January 26, 2026

Stasia Ferbey
Project Assessment Director, Power, Infrastructure, Water, Waste & Manufacturing
BC Environmental Assessment Office
Email: Stasia.Ferbey@gov.bc.ca

SUBJECT: **Response to EAO Caribou Sub-Committee Working Group Meeting Information Requests Provided by ECCC and WLRS on June 26, 2025, December 19, 2025, and January 6, 2026**

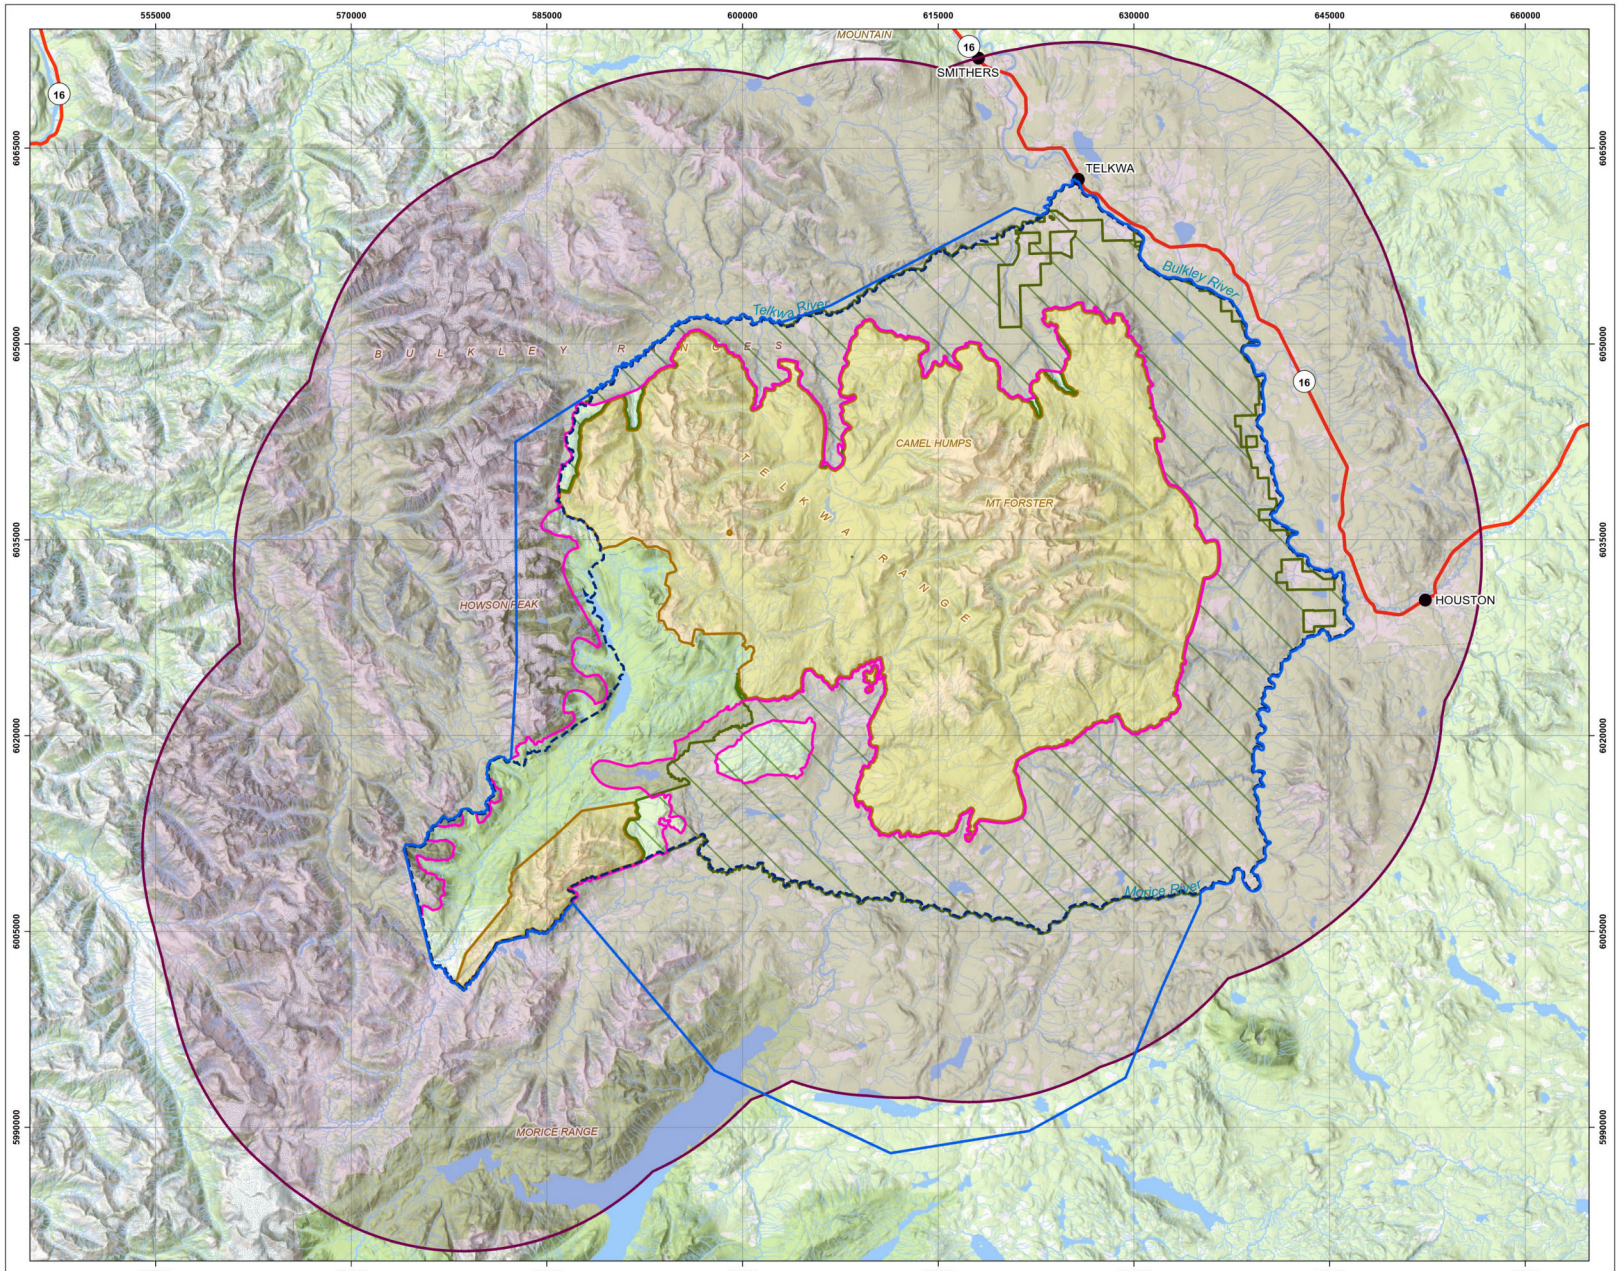
The updated map on page 13 (not page 10) of Appendix 1 (Attachment OW-026-1) does not address the comment ECCC provided on June 10, 2025.

The labelling of "Critical Habitat (ECCC 2014)" in Map 2 is inaccurate as only the "high/low elevation" component of critical habitat is included, and not the "unmapped range" component of critical habitat using linework available from the open data portal (https://open.canada.ca/data/en/dataset/47caa405-be2b-4e9e-8f53-c478ade2ca74) and provided in ECCC's June 10, 2025, comment.

ECCC recommends that either the “unmapped range” component of critical habitat be added to Map 2 as part of “Critical Habitat (ECCC 2014)” or the legend of Map 2 (and others throughout the document) be updated to read “Critical Habitat (high/low elevation range; ECCC 2014)”; and that all relevant maps make it clear that only the “high/low elevation range” component of critical habitat is defined by the proponent as the RSA-1.

TML has also revised the characterization of Critical Habitat on page 12 of Appendix 1 to explicitly acknowledge unmapped range within the LPU and that it is not explicitly addressed in the assessment.

25P0200	Production Date: Jan 15, 2026	Map 7

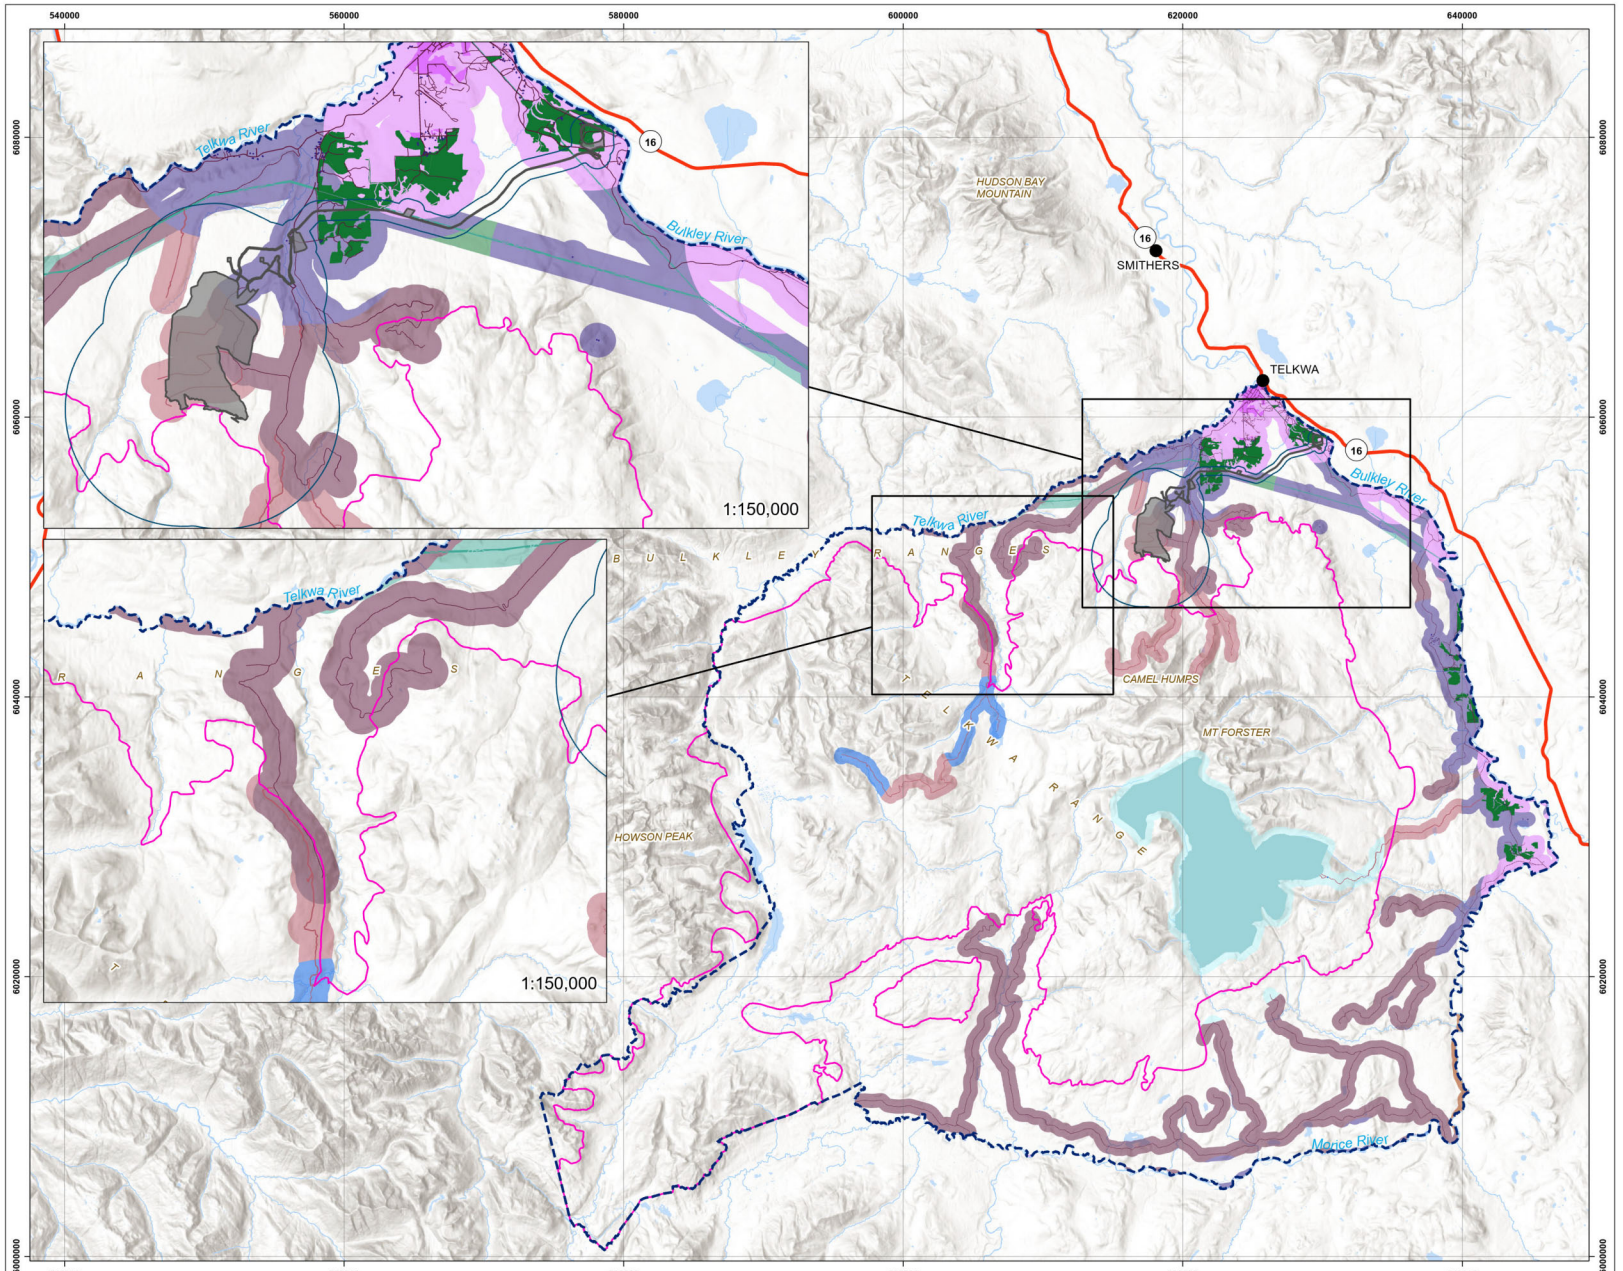
• Map 7 is labelled Current Disturbance within the Telkwa Caribou Herd's Critical Habitat and is presented immediately after Table 3, which does not represent Current Disturbance. To clarify the results of the revised effects assessment, ECCC recommends including two additional maps showing the buffers associated with permanent disturbance that form the basis of the calculations in Table 3 (i.e. one map for the indirect effects showing the variable buffers, and one map for ECCC-defined disturbed habitat showing the 500 m buffer), and to refer to those maps in the discussion of indirect effects and ECCC-defined disturbance effects.

• ECCC recommends the title of Map 7 be changed to "Current Disturbance within RSA-1" (see response to comment 1).

Telkwa Mining has updated the title of Map 7 (now Map 9) and added two additional maps (now Maps 7 and 8) to demonstrate the footprints and buffers (ZOI buffers and ECCC’s 500 m buffers) of permanent disturbances and the Project under **optimal/fully restored habitat** conditions.
